Schematic Design Report

Project: S250401 - OPAL Bayview Gardens

Date: 18th August 2025

Revision Number: B

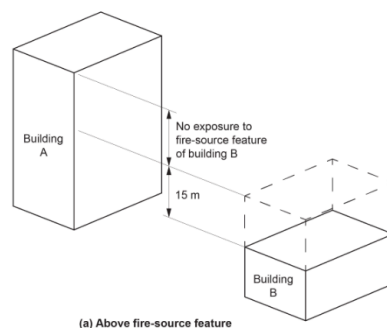
Exposure to fire-source feature as identified in BCA Specification 5 include another building located <15m above the highest part of the external wall. Plans show that AVEO Community Room will impact the eastern corner of the proposed building triggering requirement for provision of FRL to exposed building elements as identified above. This item was discussed during a design meeting with confirmation provided that the separation between OPAL building and AVEO building will be a Torrents Title Boundary which triggers the 3m separation to boundary. If this separation was only a strata boundary then 6m requirements would be triggered. FRL requirements will be assessed at a later stage but compliance is achievable. Consider

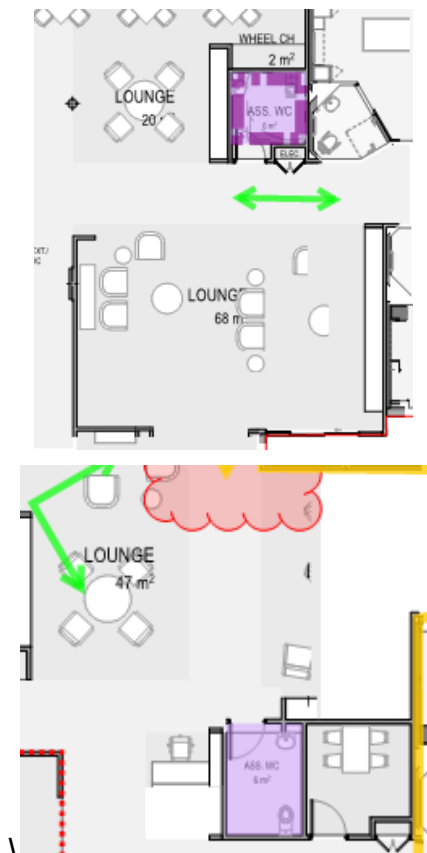
Sanitary compartments have restrictions on where they can open directly to, particularly in public and shared areas. **Please consider this as design is developed, particularly the airlock/screening requirement from public areas. Plans appear to show that the WC located on Ground Floor and Level 1 is opening directly into a lounge area with no screening provided. As discussed with the design team, similar previous projects for OPAL were provided with doors angled 90 degrees to common areas in lieu of opening directly. This item is capable of compliance and will be assessed at a later stage to ensure compliance.**
